Bulletin No.: 67-61-14B

Date: September, 1997

Engine Noise (Install Valve Stem Oil Seal)

Figure 1

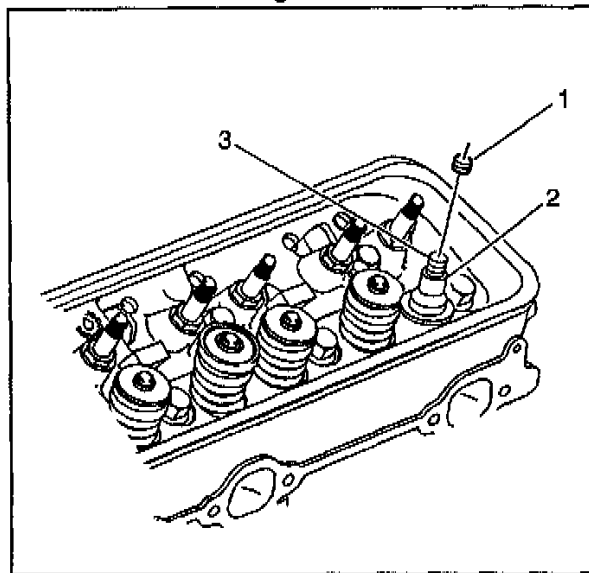
Install the valve stem oil seal listed below, ON THE EXHAUST VALVE GUIDES ONLY.

DO NOT install this seal on intake valve guides. This seal is NOT released for intake valve application in the above identified vehicles.

Lightly lubricate the seal, and with finger pressure only, push it on to the valve stem and down on to the exhaust valve guide. (See Figure 1)
